DESIGN	DRAWN BY	DART AEROSPACE HAWKESBURY, ONTARIO, CANAD	
CHECKED	APPROVED	DRAWING NO.	REV. A
RF	1/4	DEO 9143	SHEET 1 OF 1
DATE		TITLE	SCALE
99.03.03		BEARPAW COUNTERBORE	NTS
A	99.03.03	NEW ISSUE

## DART ENGINEERING ORDER

TYPICAL BEARPAW FOR ILLUSTRATIVE PURPOSES ONLY

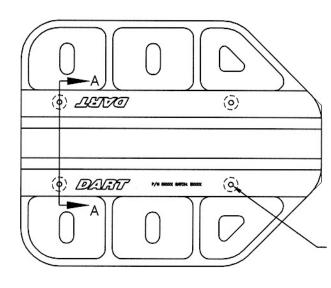
TO AMEND THE FOLLOWING DRAWINGS:

D2432 REV F D2435 REV E D2521 REV G D2671 REV B D2672 REV B

REMOVE COUNTERBORE ON TOP SURFACE OF BEARPAW.

UPDATE HOLE CALLOUT AS FOLLOWS:

Ø0.260 (TYP)
Ø0.75 C'BORE
0.30 DEEP FROM BOTTOM
(LEAVE 0.650 MIN.)
